**STATE OF MAINE
DEPARTMENT OF ENVIRONMENTAL PROTECTION
BOARD OF ENVIRONMENTAL PROTECTION**

NORDIC AQUAFARMS, INC.
Belfast and Northport
Waldo County, Maine

EXHIBIT NVC/UPSTREAM 10
TESTIMONY OF *MICHAEL LANNAN* WITH ATTACHMENTS

BLASTING

PRE-BLAST SURVEY DRAWING

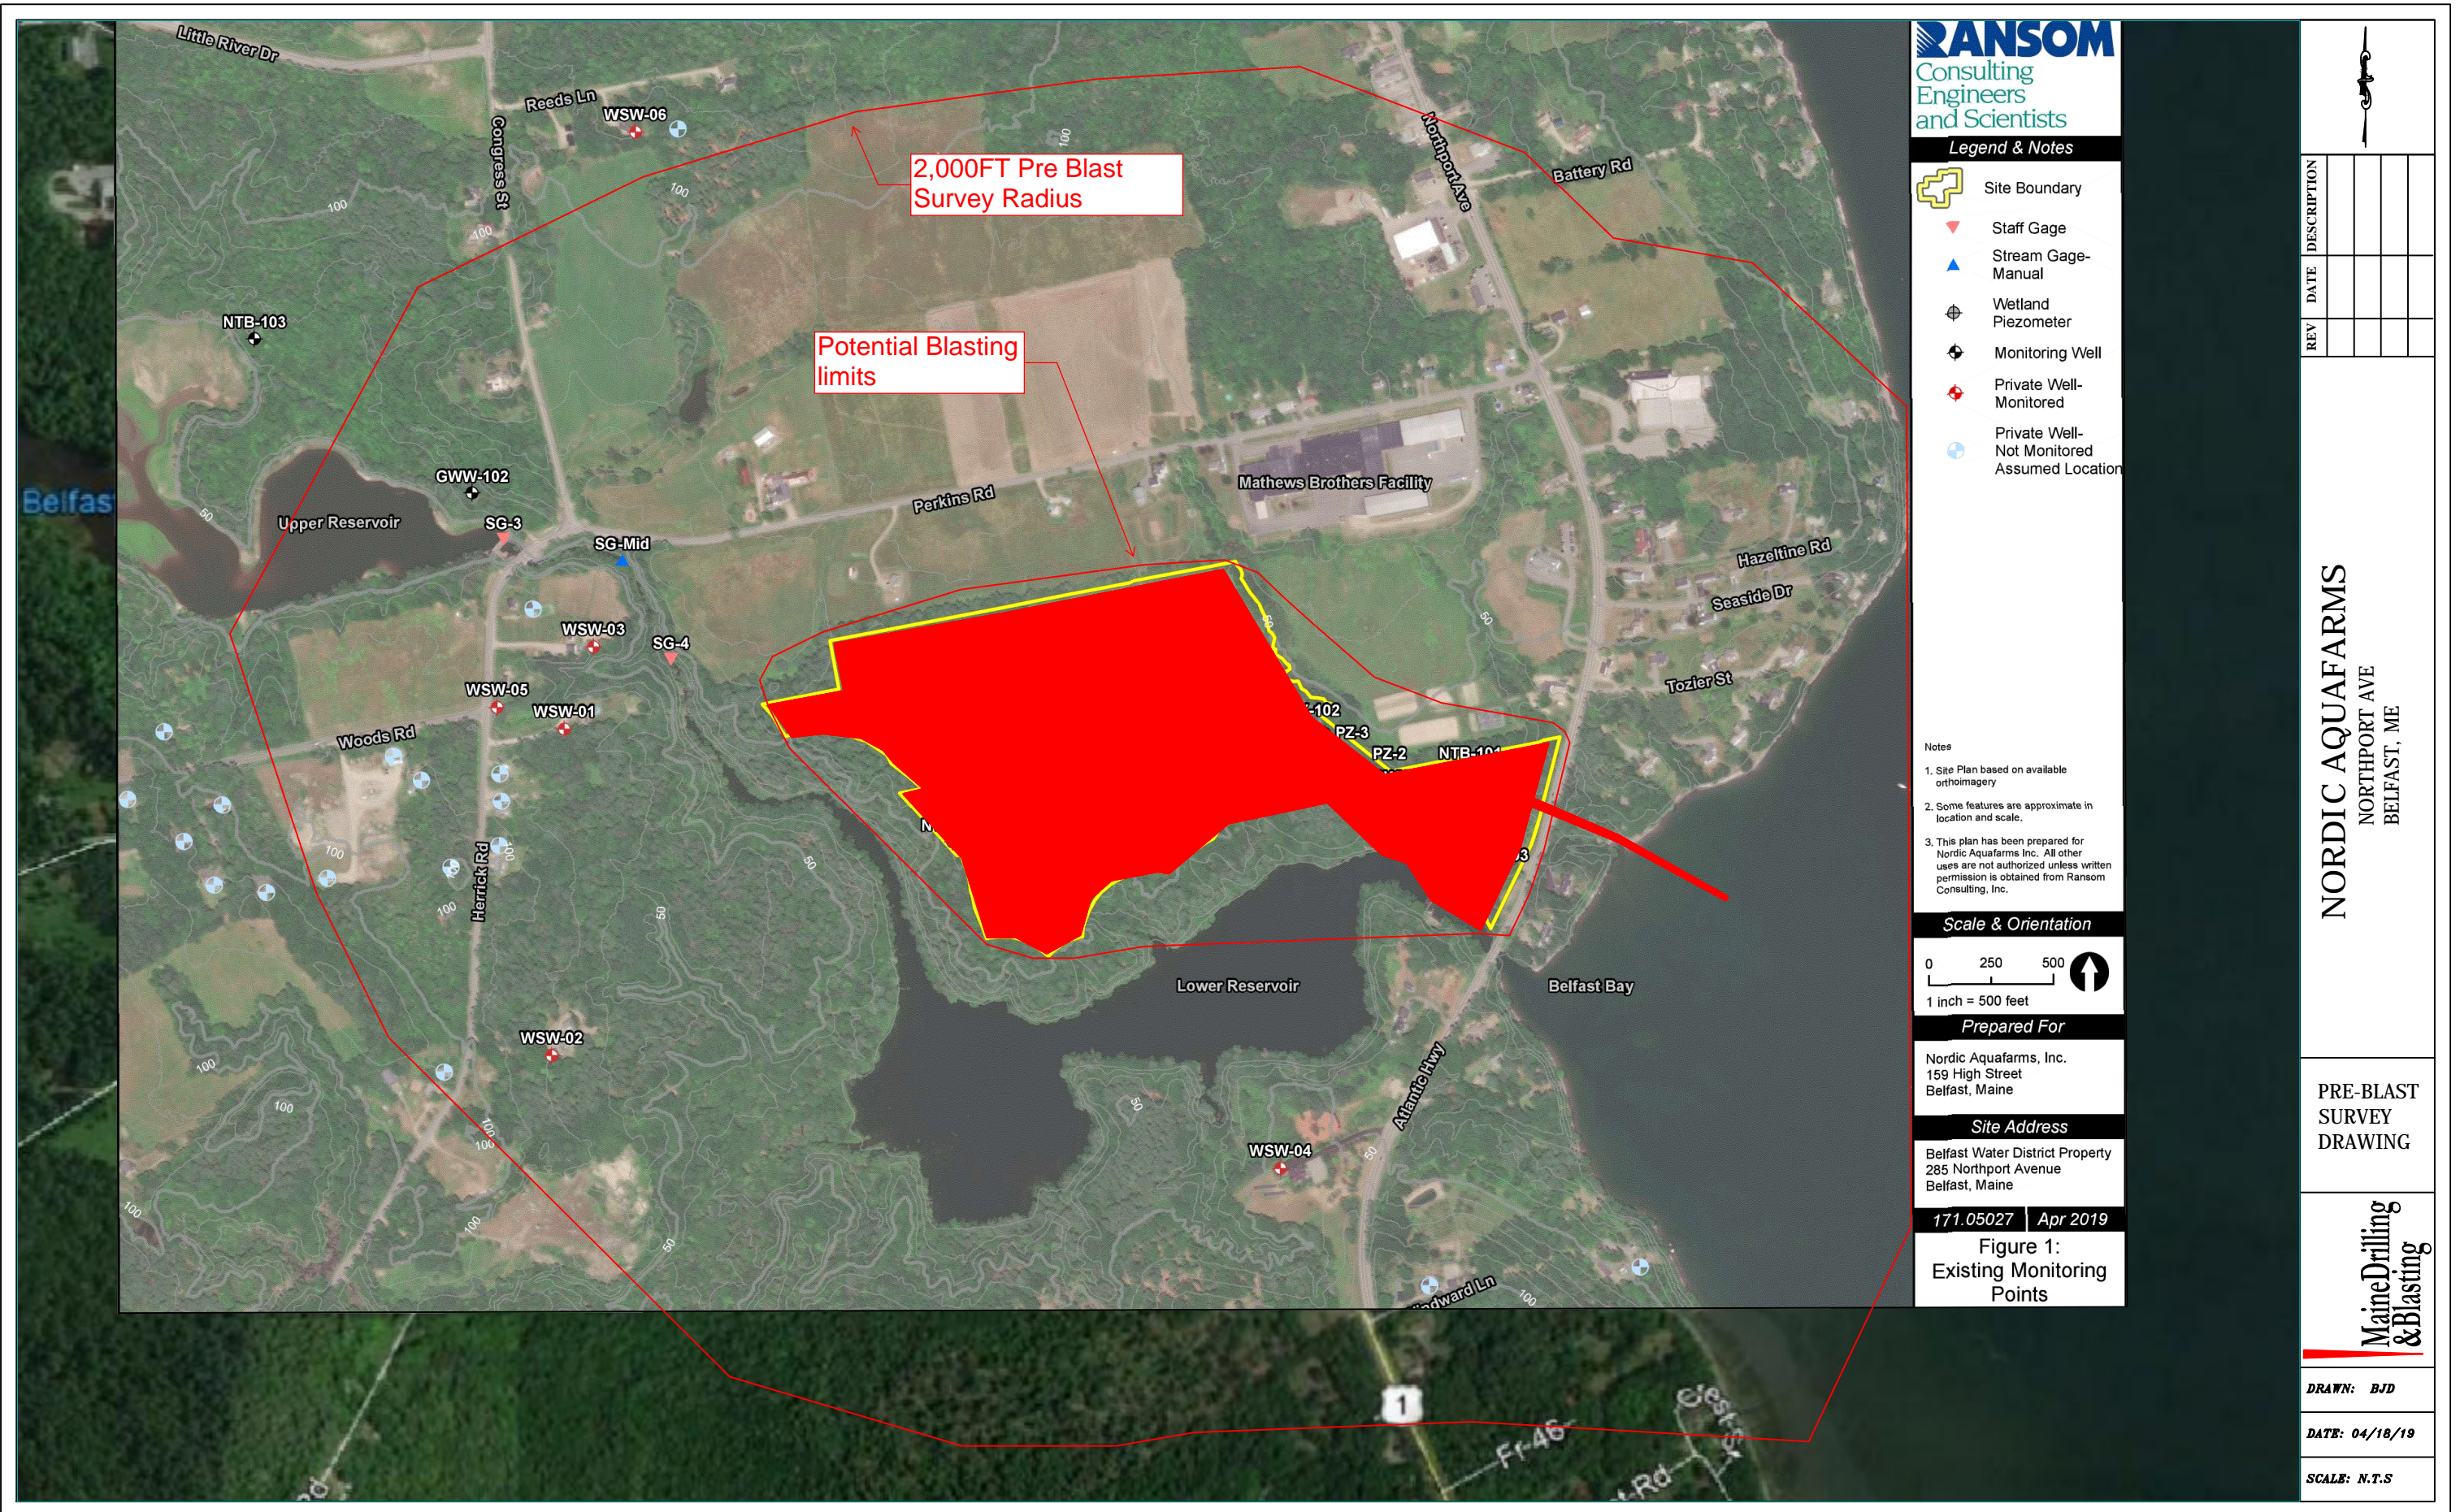
In the Blasting Plan prepared by Maine Drilling & Blasting, Inc. a Pre-Blast Survey Drawing was provided showing the project site, with an outline outside the project area, labeled as the “**Potential Blasting Limits**”. The limits are outside of the project site, and onto protected locations, and it is unclear what the drawing is trying to depict with outlining the potential blasting limits. That figure is included as Attachment A. Please note that according to this plan, blasting could occur adjacent to the existing lower dam structure. Both the lower and upper dams are old and in disrepair, water leaks through cracks in the upper dam during higher reservoir levels. Clearly, there is no “*Assessment of the potential for adverse effects of blasting on protected natural resources and structures* (i.e. the old dams).
